CITY COUNCIL STUDY SESSION

FEMA OPEN PACIFIC COAST STUDY UPDATE

EARLY CONCLUSIONS

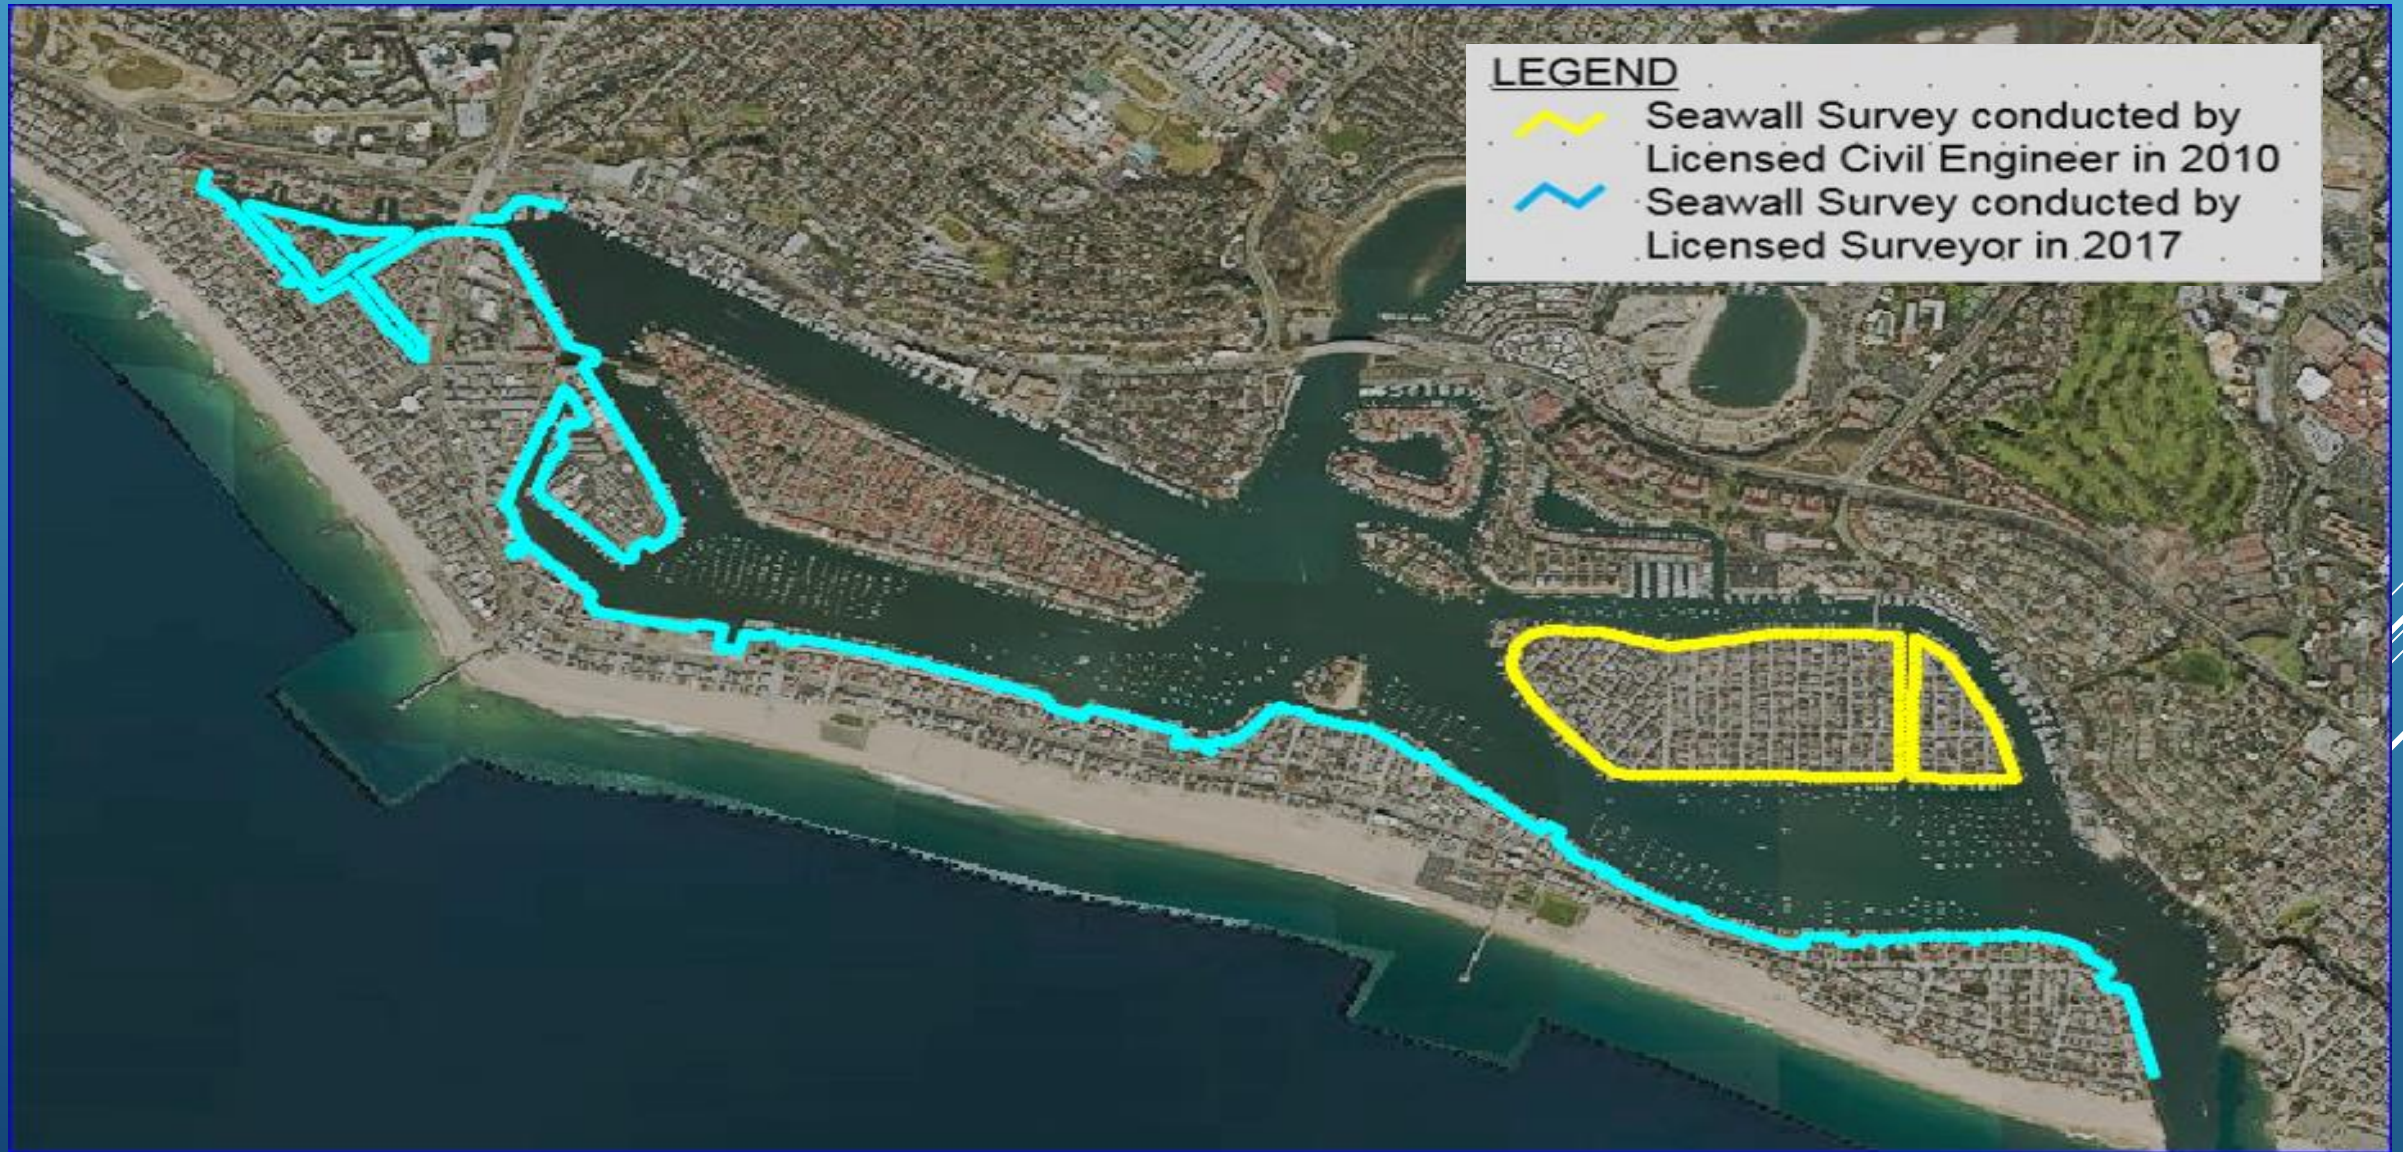
- ▶ FEMA did not take into account the height of our seawalls.
 - ▶ FEMA did not use Hydrodynamic modeling to calculate flood elevation. They only compared the elevation of grade to water level.
- 
- A series of white diagonal lines of varying lengths and thicknesses are positioned in the bottom right corner of the slide, creating a modern, abstract graphic element.

Figure 9. Proposed Revised VE Zone Extent for Zone 16

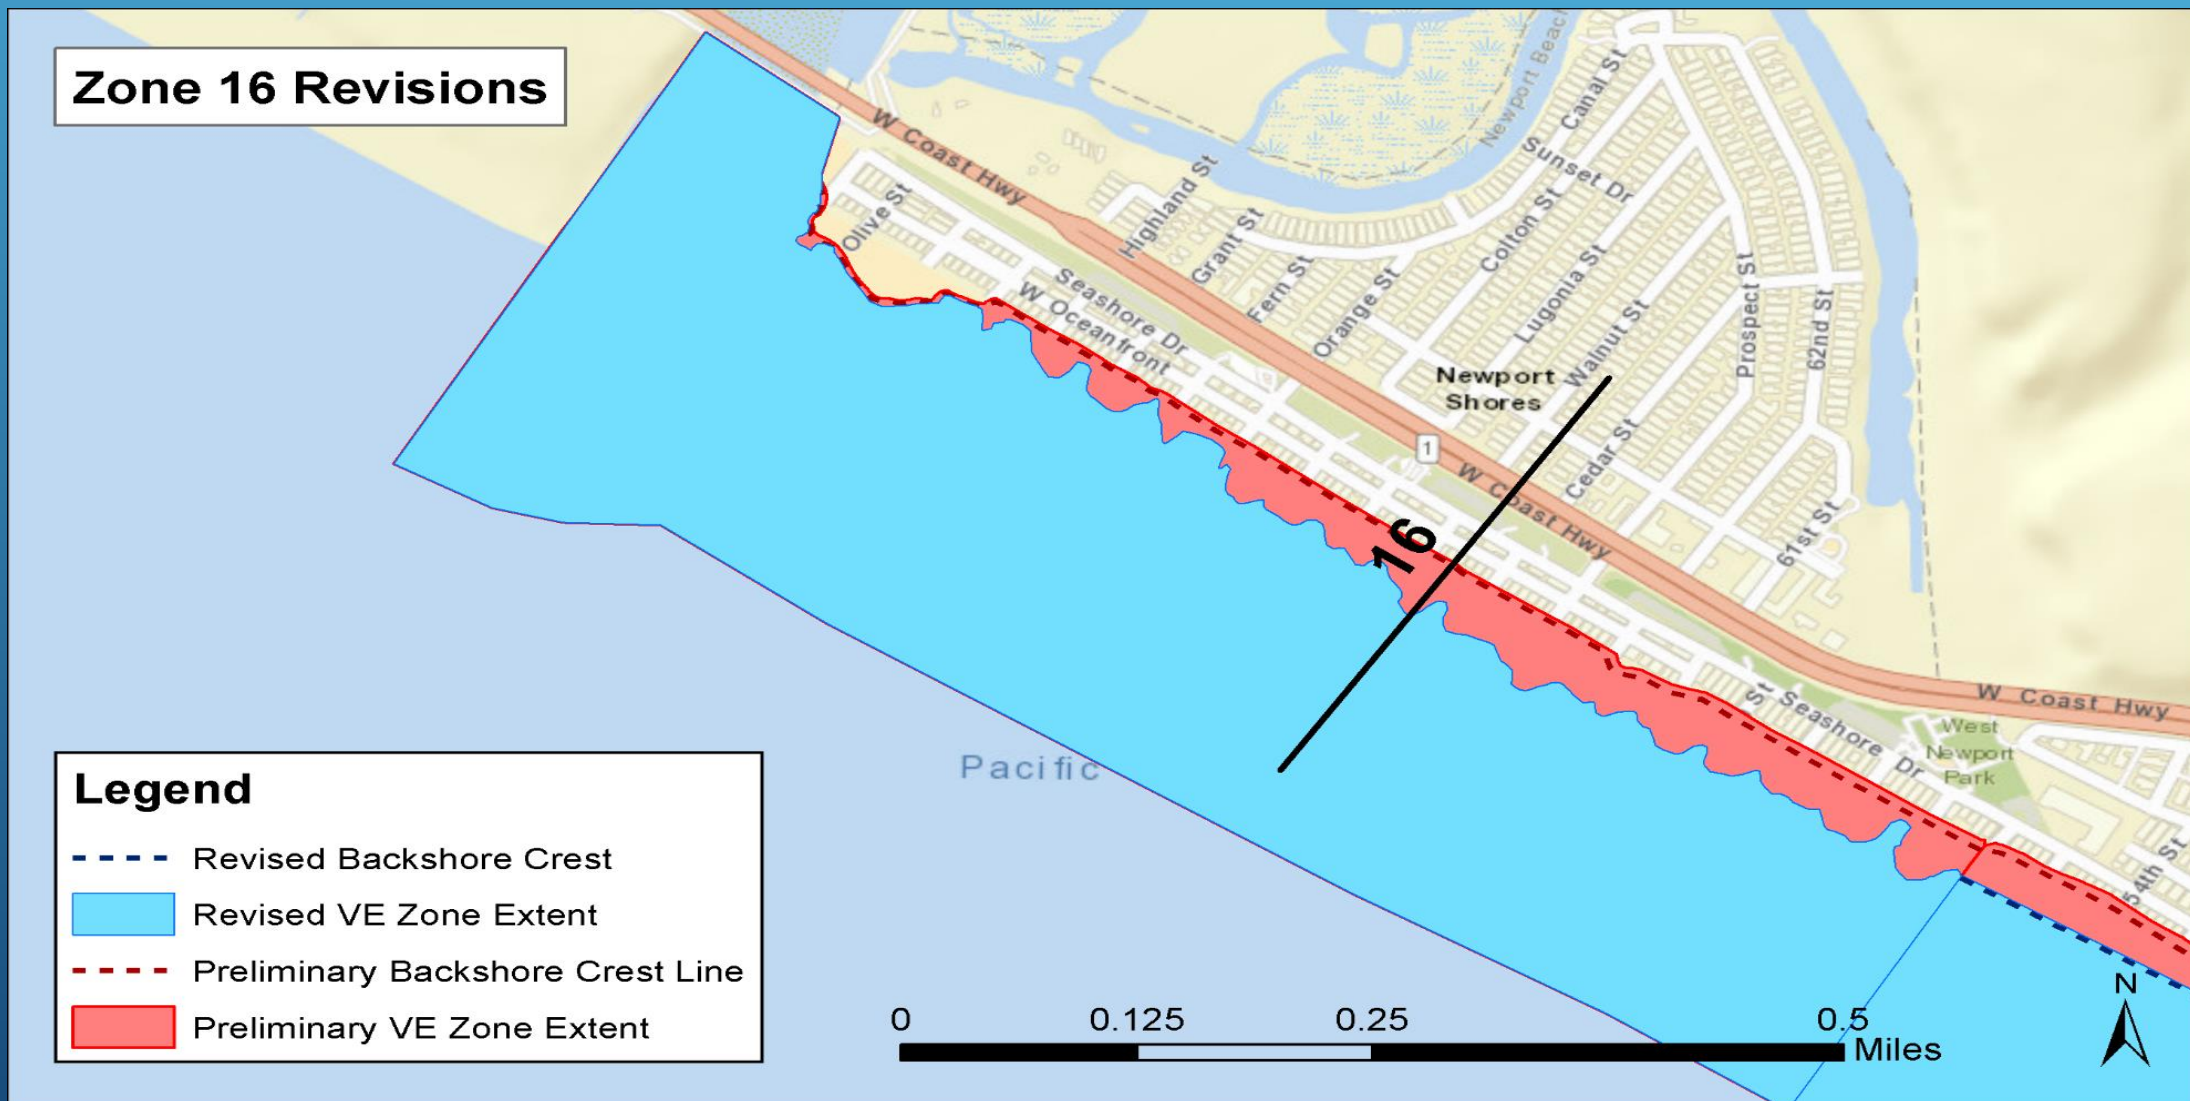
1. Established an average beach profile at 200 foot intervals vs. FEMA's one non-representative beach profile.
2. Modeled Berming as a select “backshore” feature that are created in advance of large ocean swells (City's Existing Practice)
